Addendum

Iowa Department of Transportation Contracts & Specifications Bureau Date of Letting: February 18, 2025 Date of Addendum: January 29, 2025

C.O	Proposal ID	Proposal Work Type	County	Project Number	Addendum
157	41-0184-030	HMA PAVEMENT WIDENING / HMA RESURFACING	HANCOCK	NHSX-018-4(30)3H-41 NHSX-018-4(041)3H-41	18FEB157A01

Make the following change to the NHSX-018-4(30)--3H-41 plans:

SHEET NUMBER N.1

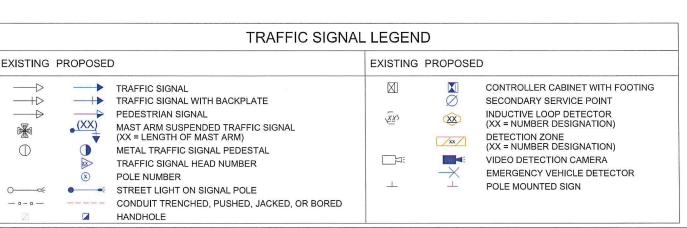
Replace plan sheet N.1 with the attached.

Revise General Notes on Sheet N.1 as follows:

- 11. Relocate and reinstall existing McCain ATC traffic signal controller in new cabinet. Cabinet shall be a 16 channel HV ATC cabinet with 16 channel CMU, switchpacks, and auxiliary equipment. Cabinet and cabinet equipment shall be fully-compatible with the existing controller.
- 22. Detection system shall be hybrid video/radar to provide reliable advance and stop line detection. Detection system shall include 5 years of remote access and a 5-year warranty.
- 23. Emergency vehicle preemption (EVP) system shall be siren-activated.

- 10. PROVIDE ONE WEEK NOTICE TO IOWA DOT DISTRICT OFFICE BEFORE PLACING THE TRAFFIC SIGNAL INTO OPERATION.
- 11. RELOCATE AND REINSTALL EXISTING MCCAIN ATC TRAFFIC SIGNAL CONTROLLER IN NEW CABINET. CABINET SHALL BE A 16 CHANNEL HV ATC CABINET WITH 16 CHANNEL CMU, SWITCHPACKS, AND AUXILIARY EQUIPMENT. CABINET AND CABINET EQUIPMENT SHALL BE FULLY-COMPATIBLE WITH THE EXISTING CONTROLLER.

- 22. DETECTION SYSTEM SHALL BE HYBRID VIDEO/RADAR TO PROVIDE RELIABLE ADVANCE AND STOP LINE DETECTION. DETECTION SYSTEM SHALL INCLUDE 5 YEARS OF REMOTE ACCESS AND A 5-YEAR WARRANTY.

- 23. EMERGENCY VEHICLE PREEMPTION (EVP) SYSTEM SHALL BE SIREN-ACTIVATED.
- 24. THE SIGNAL CABINET ADDRESS WILL BE THE SAME AS THE CURRENT SIGNAL CABINET.
